AMENDMENT 1

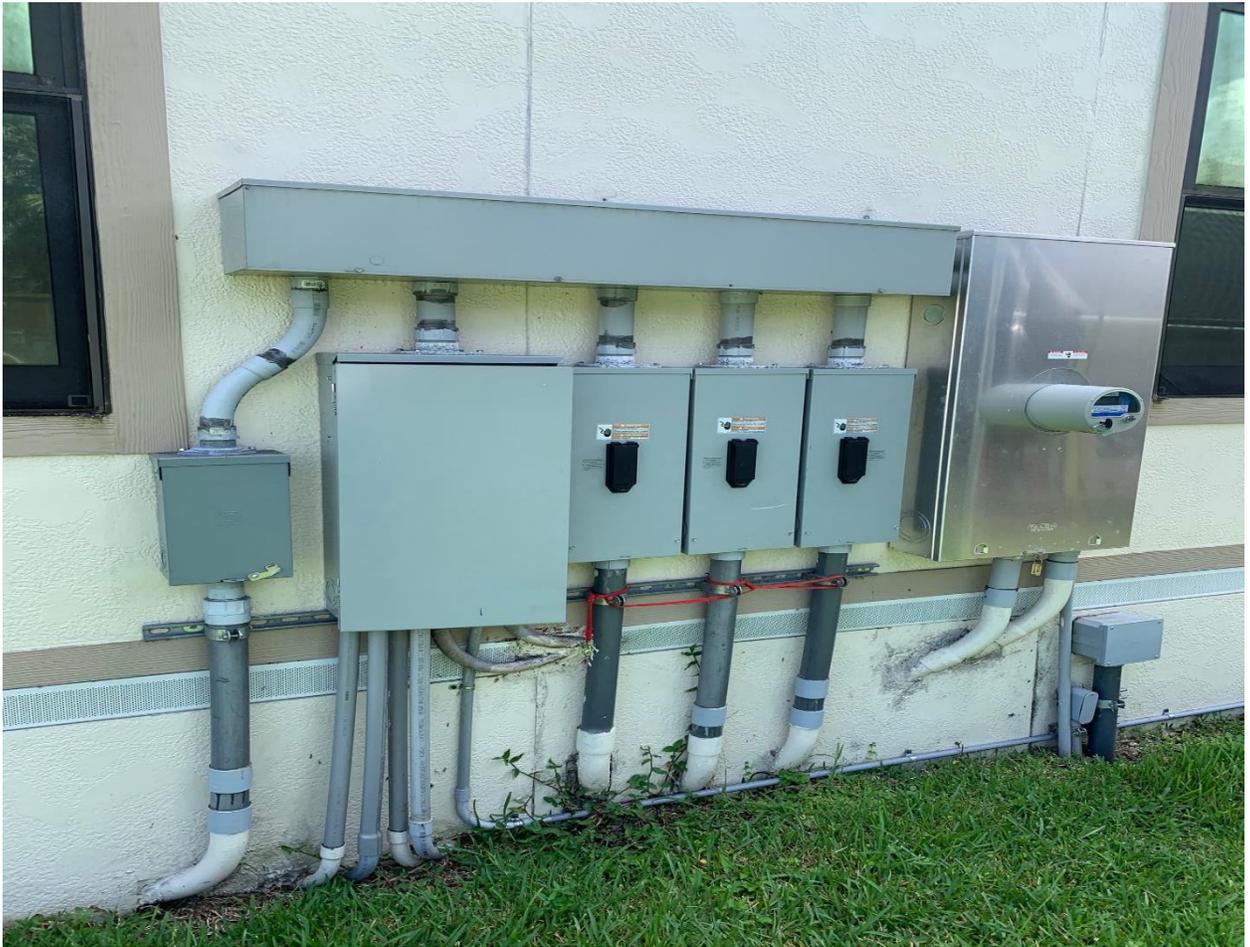
1. Existing electrical riser plan shows 3 enclosed circuit breakers and a 200amp panel. Actual field conditions are 4 enclosed circuit breakers that are rated at 3 @150 amps and 1 @100amps and a 200amp panel. (See picture below). Does the 100amp circuit need to be backed up to the emergency generator? **The design intent is for a 'full system' backup. Yes, the 100A circuit should be included in the new MDP**
